# Inglewood Transit Connector Project

## Final Environmental Impact Report

**Final  
Environmental Impact Report  
for the  
Inglewood Transit Connector Project  
SCH NO. 2018071034**

Map of Sensitive Receptors - Index

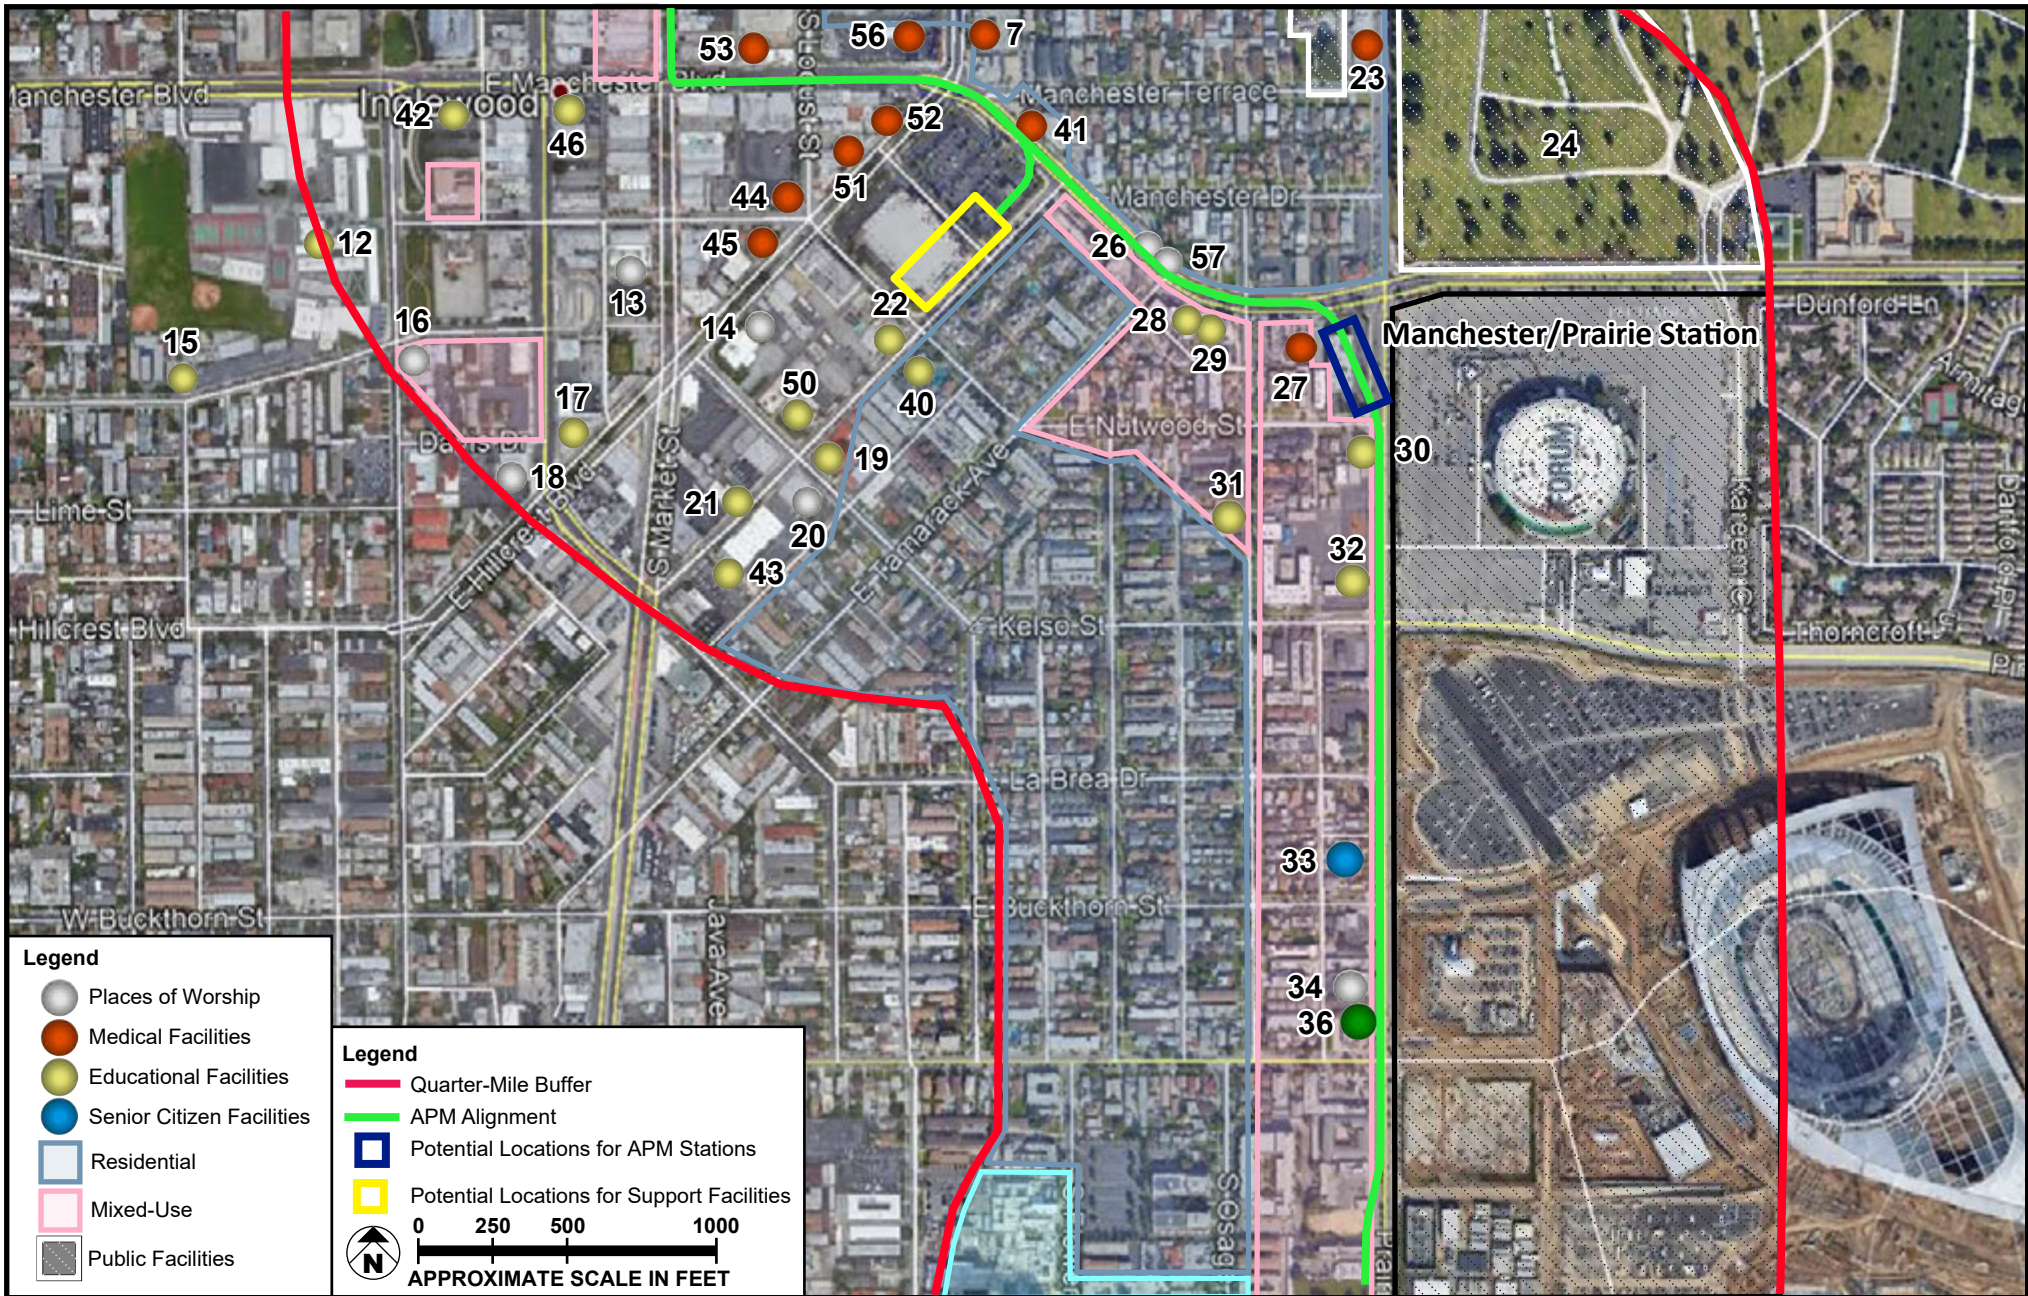
The revision has been made to correct the potential location of PDS substations in **Figure 4.0-2: Map of Sensitive Receptors - Index**, **Figure 4.0-3b: Sensitive Receptors within a Quarter-Mile of the Project Area**, and **Figure 4.0-3c: Sensitive Receptors within a Quarter-Mile of the Project Area** on Pages 4.0-31, 4.0-33, and 4.0-34 of the RDEIR.
